Jefferson Proving Ground Madison, Indiana

Draft Final Phase II Remedial Investigation

Re: Draft Final Remedial Investigation
Jefferson Proving Ground,
Madison, IN

Figure 5-3. Facility-Wide Conceptual Model

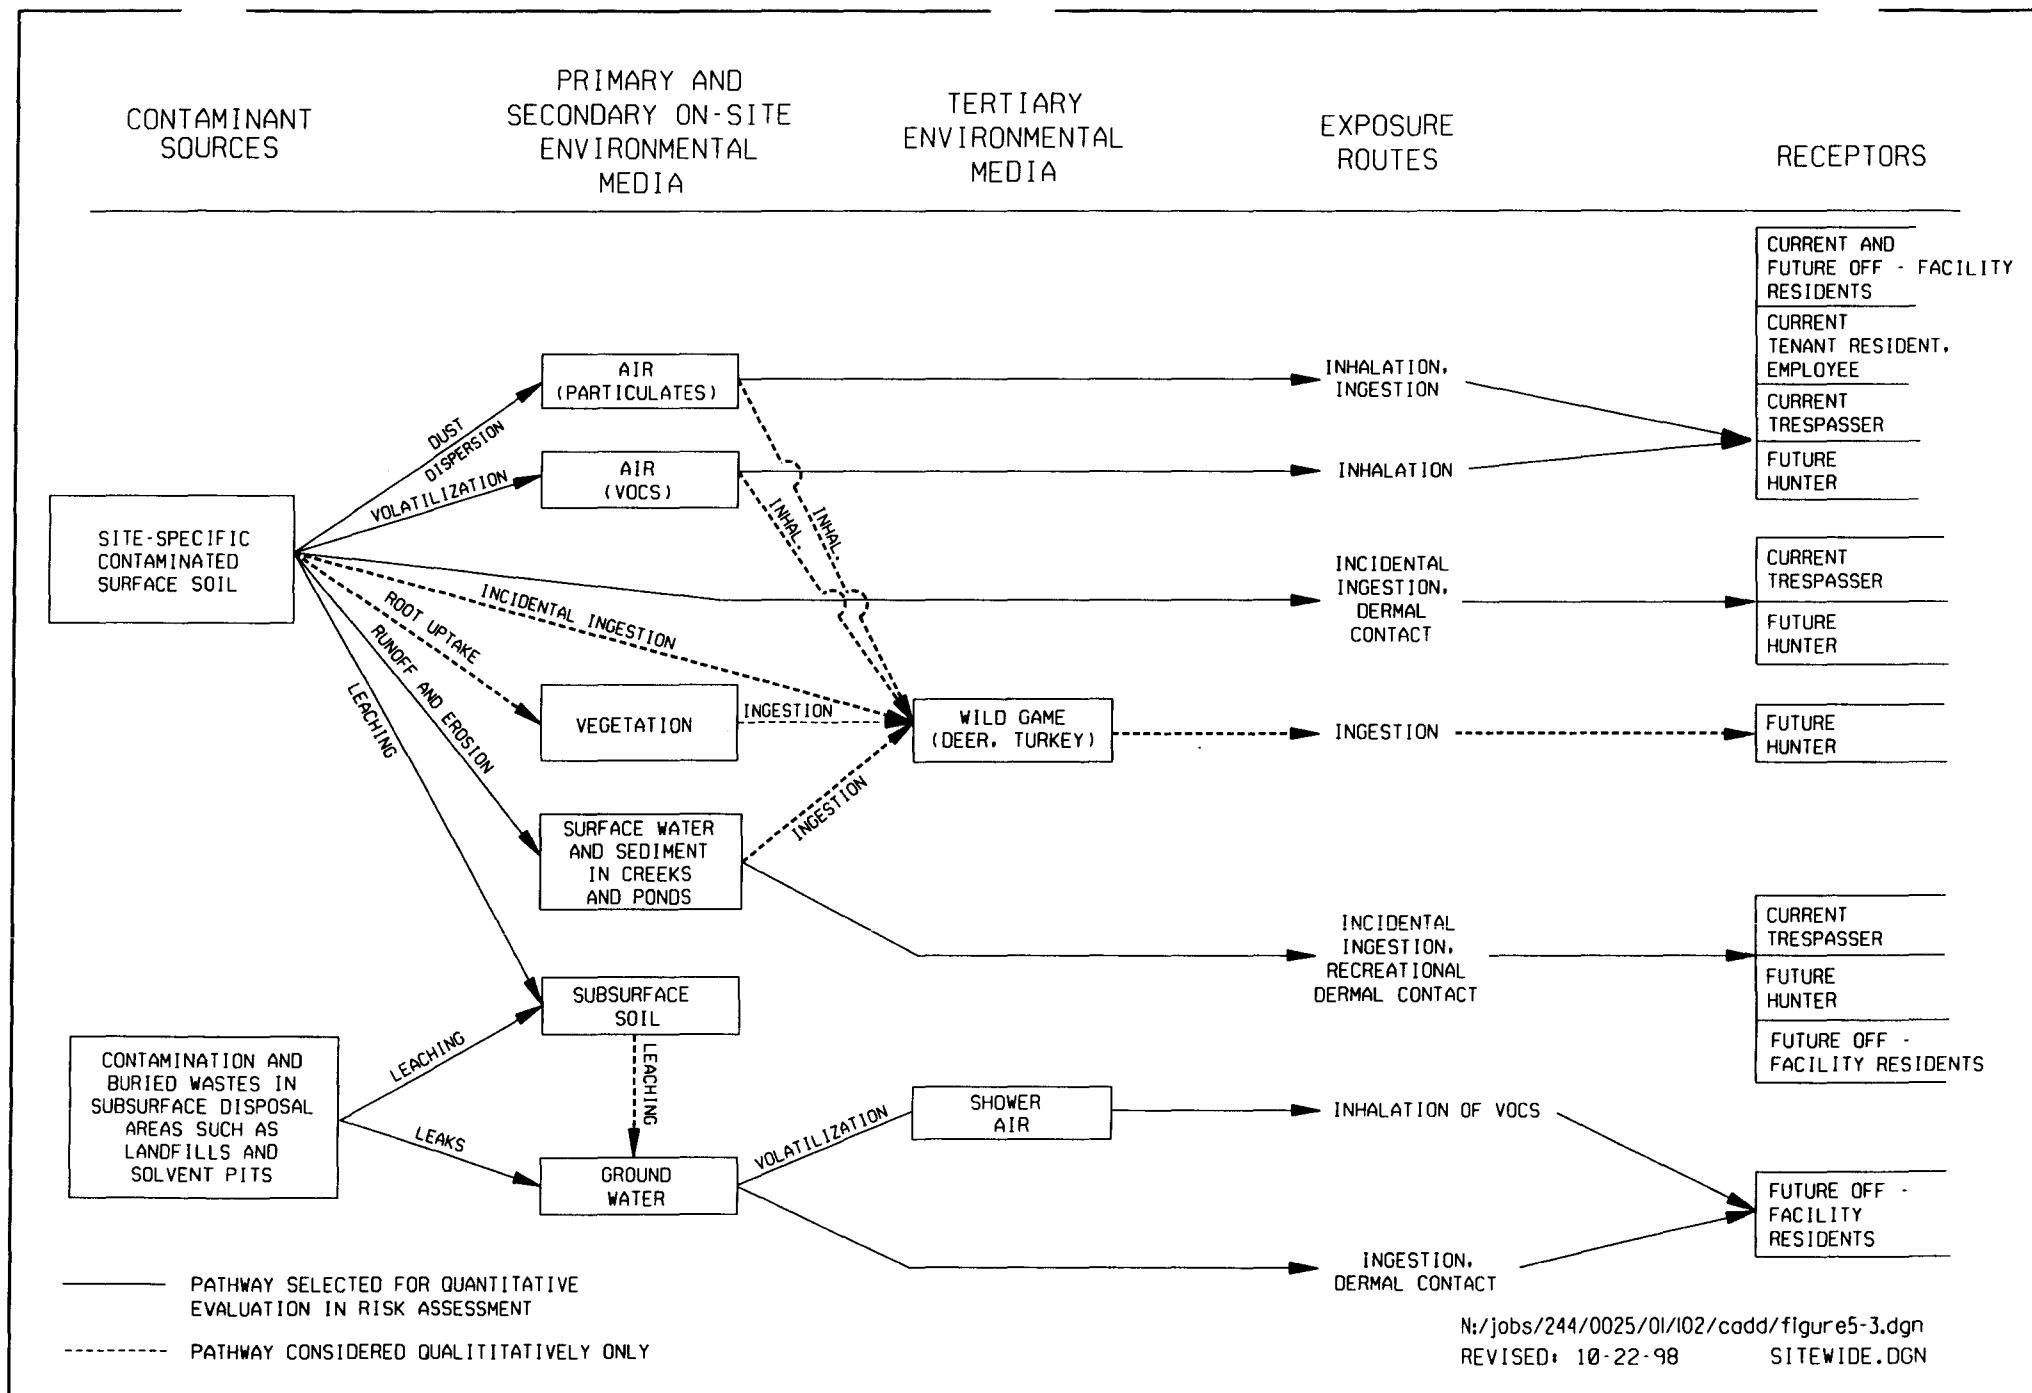
| Comment # | Section | Comment (EPA/IDEM as indicated in comment number) | Original Response to Comment (ET) | MW Revised Response (if applicable) | Agency Concur |
|-----------|--------------------|---|---|---|---------------|
| EPA148 | 05.1 Figure 5-3 | 24. Page 5-43, Section 5.1.4.6.1, Facility-Wide Conceptual Site Model: Future Land Use Scenario: Residents - If impacted shallow groundwater is assumed to underlie residential homes, exposures due to inhalation of VOCs volatilizing to ambient air and inside homes must be considered. Although this section outlines potential inhalation of VOCs arising from subsurface soil for this receptor population, this exposure pathway is not presented in Figure 5-3, the Facility-Wide Conceptual Site Model. | See response to General Comment 5 (EPA120). Figure 5-3 will be modified to include VOC emissions from soil. | Figure has been modified as requested. | |

| Comment # | Section | Comment (EPA/IDEM as indicated in comment number) | Original Response to Comment (ET) | MW Revised Response (if applicable) | Agency Concur |
|-----------|---------------|--|---|--|---------------|
| EPA139 | Figure 05-3 | 16. Page 5-36, Figure 5-3, Facility-Wide Conceptual Model: Based on a review of the entire risk assessment methodology, this model lacks the following: All Current and Future Receptors: <ul style="list-style-type: none">• Subsurface Soil - Inhalation of VOCs• Groundwater - Inhalation of VOCs Current Security Guard or Maintenance Worker contact with (tentative) <ul style="list-style-type: none">• Surface Soil - Incidental Ingestion, Inhalation of VOCs and Particulates, Dermal Contact• Subsurface Soil - Inhalation of VOCs• Groundwater - Inhalation of VOCs | See response to General Comment 5 (EPA120) for the inhalation of VOCs and the maintenance worker. | No additional response necessary. | |

Figure 5-4. Site-Specific Conceptual Model

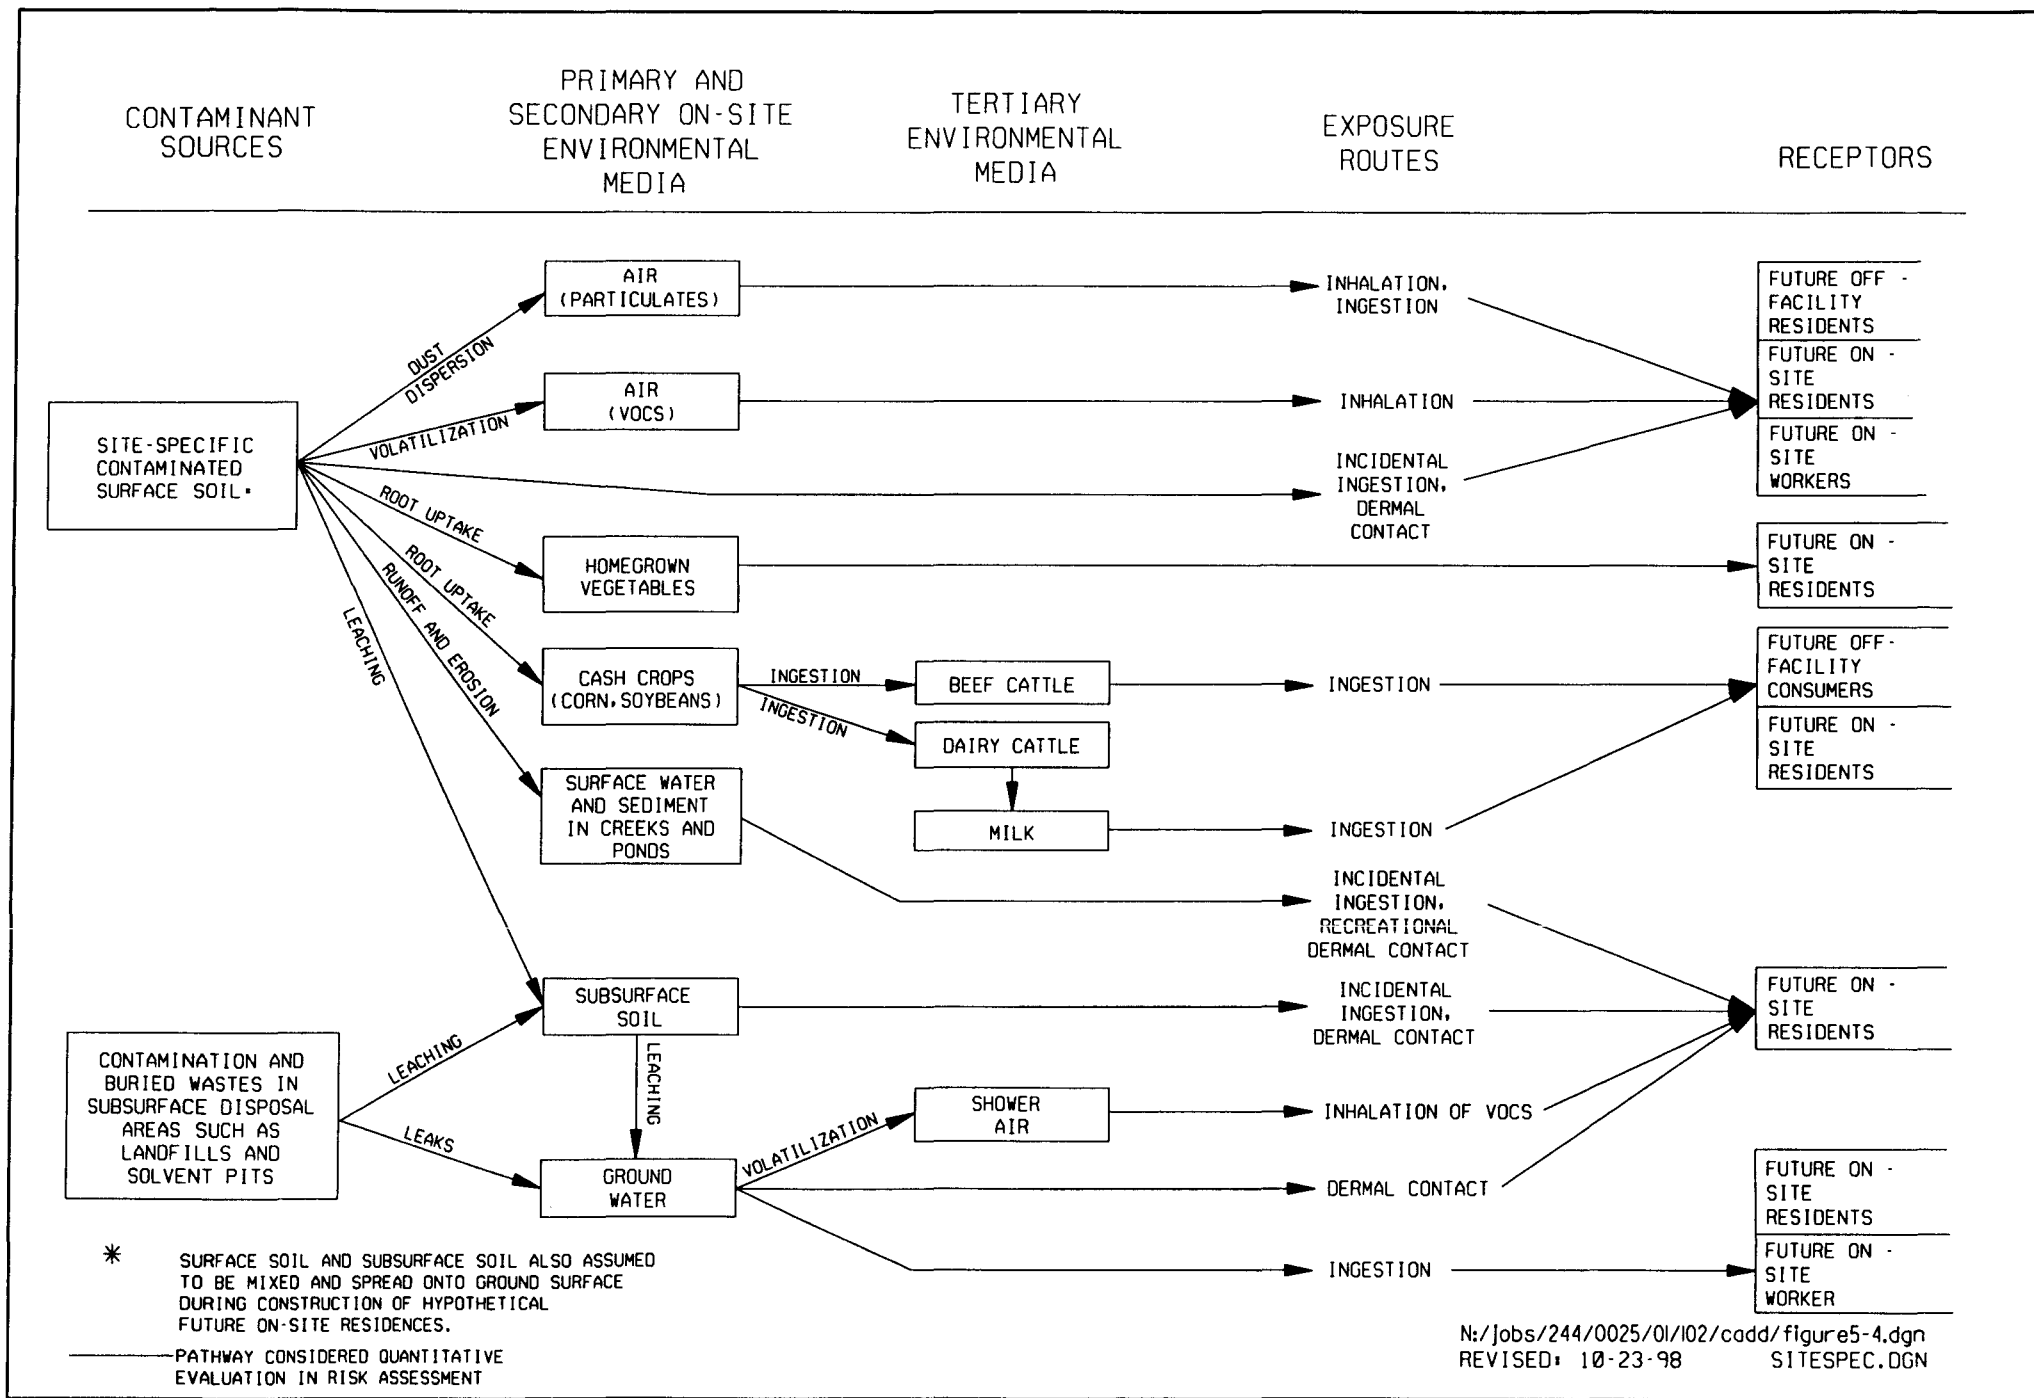
| Comment # | Section | Comment (EPA/IDEM as indicated in comment number) | Original Response to Comment (ET) | MW Revised Response (if applicable) | Agency Concur |
|-----------|----------------------------|--|--|--|---------------|
| EPA140 | Figure 05-4 | <p>17. Page 5-37, Figure 5-4, Site Specific Conceptual Model: Based on a review of the entire risk assessment methodology, this model lacks the following:</p> <p>Future Construction Worker contact with:</p> <ul style="list-style-type: none"> • Surface Soil - Incidental Ingestion, Inhalation of VOCs and Particulates, Dermal Contact • Subsurface Soil - Incidental Ingestion, Inhalation of VOCs and Particulates, Dermal Contact • Groundwater - Inhalation of VOCs, Dermal Contact (and ingestion should a water supply well be installed - this is considered when evaluating the future on-site worker scenario) <p>All Current and Future Receptors contact with:</p> <ul style="list-style-type: none"> • Subsurface Soil - Inhalation of VOCs • Groundwater - Inhalation of VOCs <p>Future Maintenance Worker contact with:</p> <ul style="list-style-type: none"> • Surface Soil - Incidental Ingestion, Inhalation of VOCs and Particulates, Dermal Contact • Subsurface Soil - Inhalation of VOCs • Groundwater - Inhalation of VOCs <p>Current/Future Agricultural Worker contact with (assumed to already have contact with contaminated beef and milk):</p> <ul style="list-style-type: none"> • Surface Soil - Incidental Ingestion, Inhalation of VOCs and Particulates, Dermal Contact • Subsurface Soil - Inhalation of VOCs, Inhalation of VOCs and Particulates, Dermal Contact • Groundwater - Inhalation of VOCs, Dermal Contact <p>Future Beef and Dairy Cattle (milk) concentrations could be influenced by surface soil concentrations as well as groundwater if used for stock watering.</p> | See response to General Comment 5 (EPA120). The future agricultural worker is identified in the assessment as the rural resident at each site and the rural resident was evaluated for the pathways specific for surface soil and subsurface soil. At every site where groundwater data were available, inhalation of shower VOCs and dermal contact with groundwater were evaluated if the concentration exceeded the tap water PRG. | Comment addressed as discussed at EPA 120a. | |

Figure 7-3. Contaminant Distribution Maps for Surface Soils at Sites 2/27

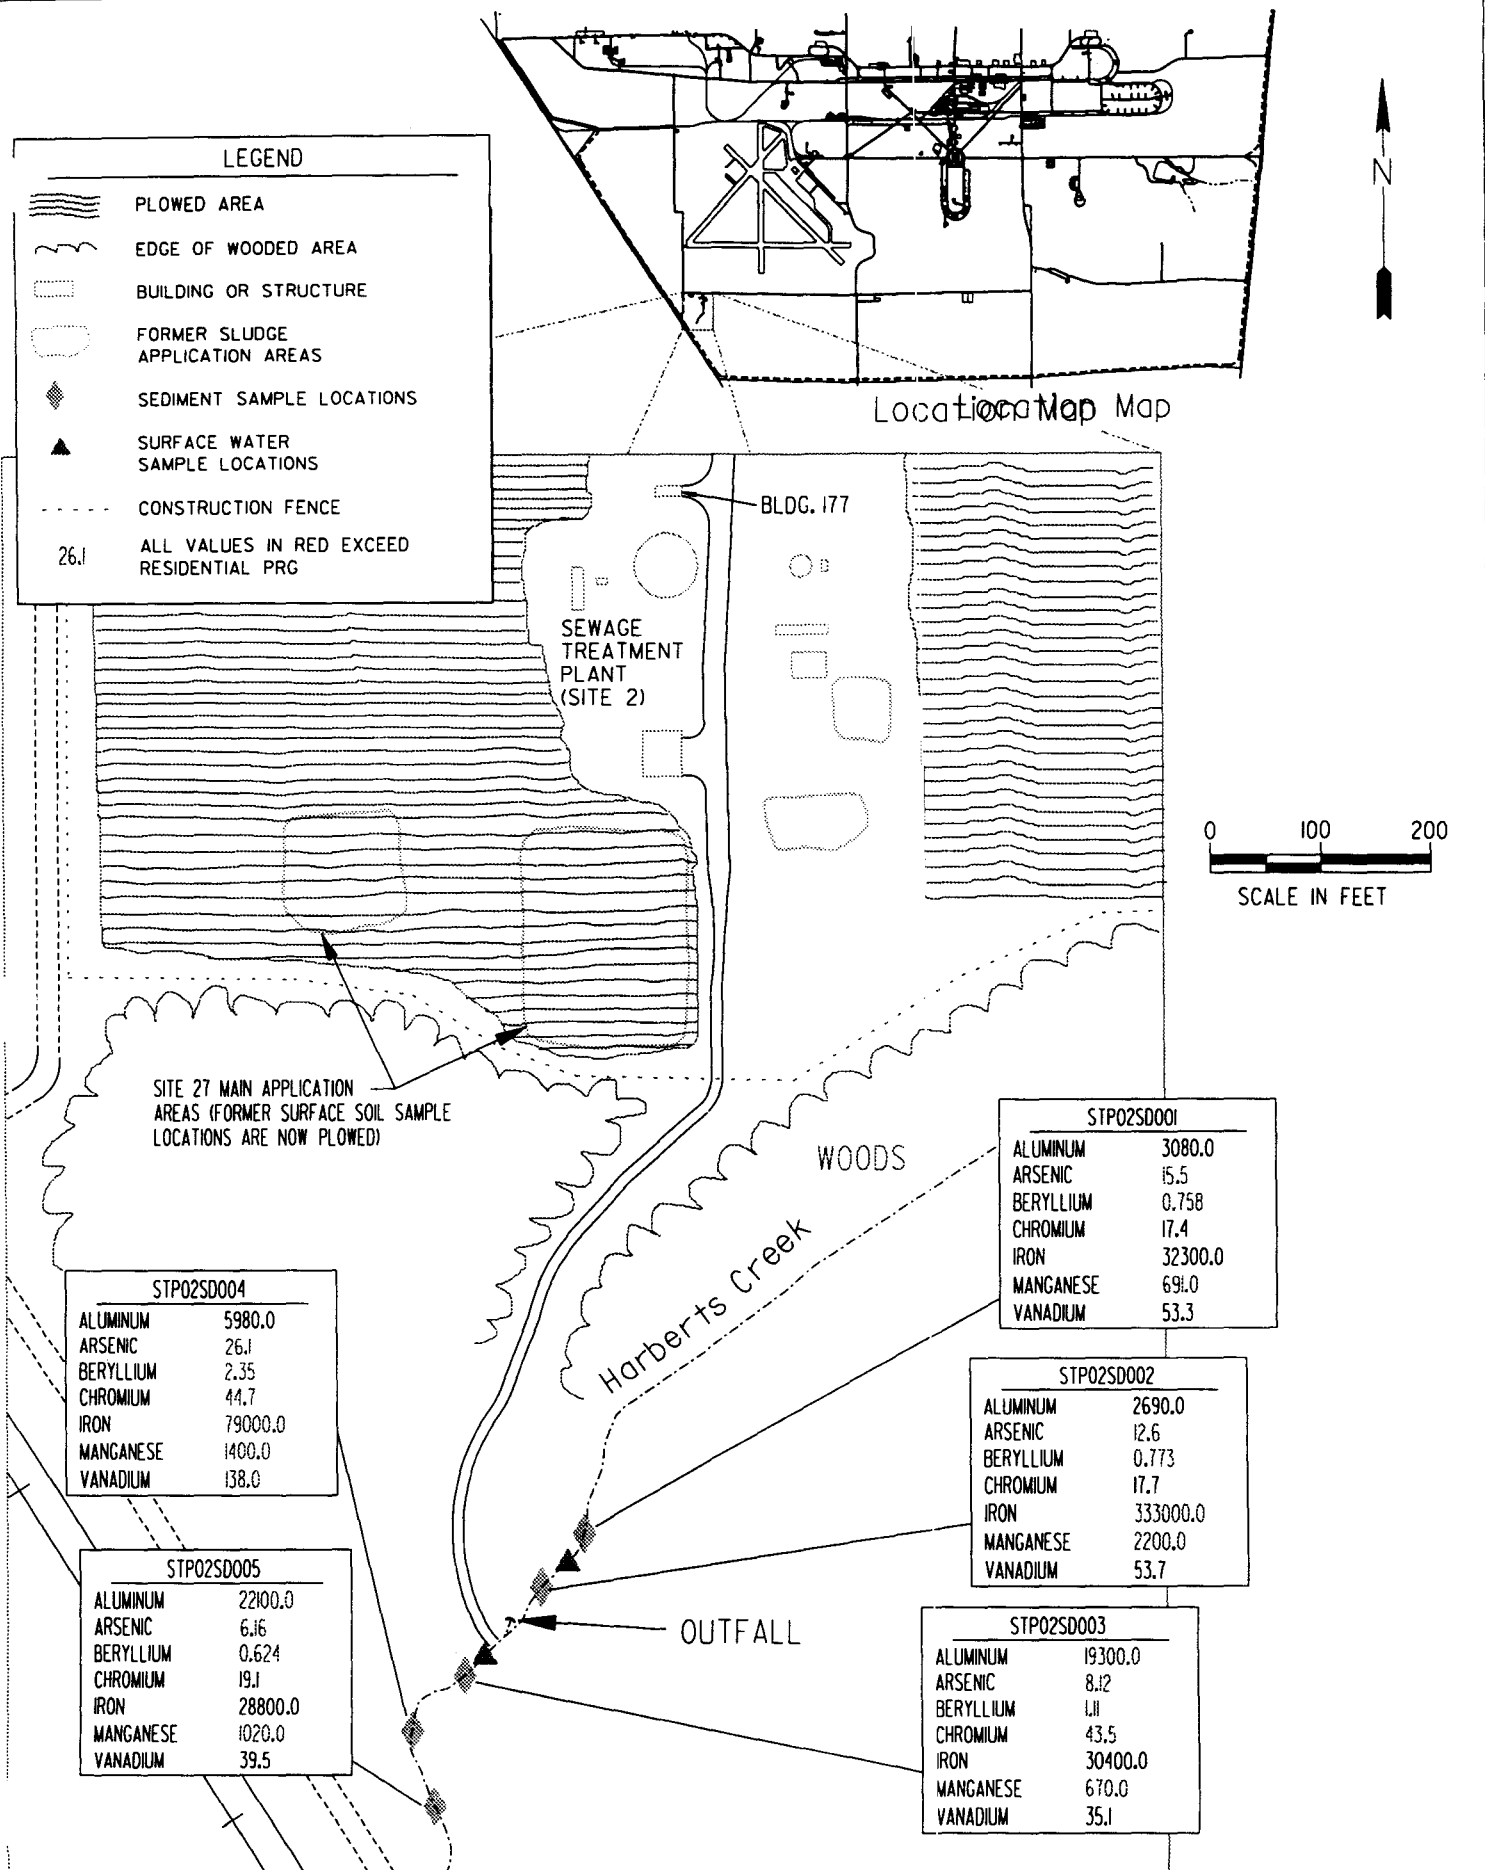
| Comment # | Section | Comment (EPA/IDEM as indicated in comment number) | Original Response to Comment (ET) | MW Revised Response (if applicable) | Agency Concur |
|-----------|---------|--|---|--|---------------|
| IN14 | 07.5.1 | Section 7.5.1, Page 7-28, Paragraph 2: The text at the end of this paragraph states “(see Figure 7-2).” This should read “(see Figure 7-3).” | Reference in Section 7.5.1 will be corrected to “(see Figure 7-3).” | Comments addressed per ET’s response. | |
